<b>Subject:</b>  SIDE(S) OF REAR SEAT CUSHION IS LIFTING OR LOOSE	<b>Bulletin No:</b> 09-024/14
	<b>Last Issued:</b> 08/15/2014

- This bulletin supersedes the previous bulletin 09-024/14 issued on 05/27/14. The REPAIR PROCEDURE and PARTS INFORMATION have been revised.
- Changes are noted below beside the change bar in Red.

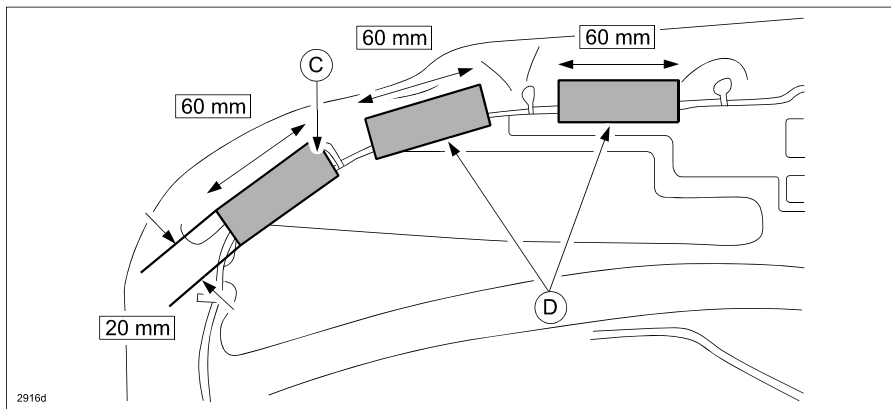
4. Attach 3 pieces of Velcro tape (BHY1-88-472) in the locations shown.  
C: Attach the Velcro tape to the side of the the C-ring  
D: Attach the Velcro tape to the center of the C-rings.

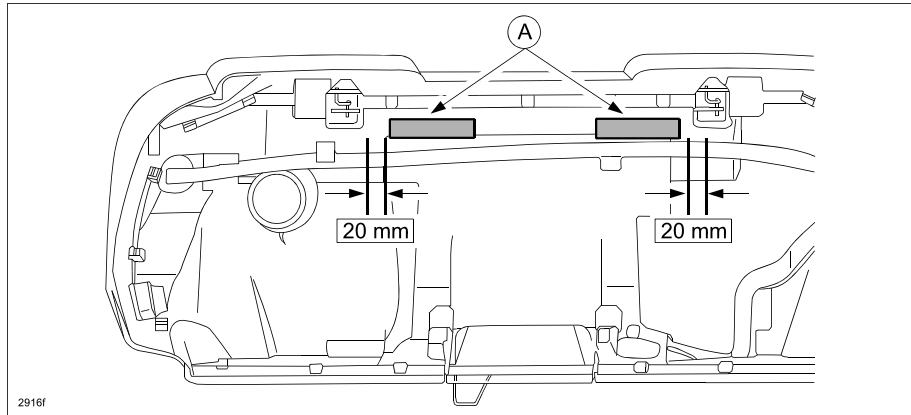
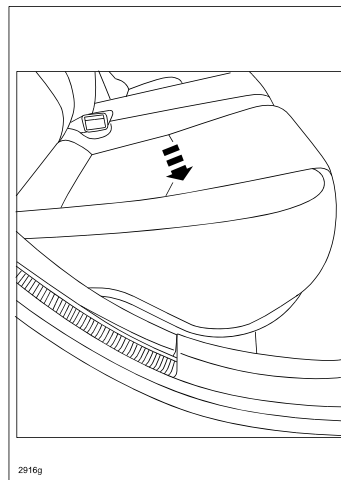
- Attach Velcro tape to the opposite side of the rear seat cushion using the same procedure.
- Attach the felt (BHY1-88-093, 6 mm thickness) to the bottom front edge of the rear seat cushion (A) as shown.

**NOTE:** If using the old felt (3 mm thickness), attached two layers.
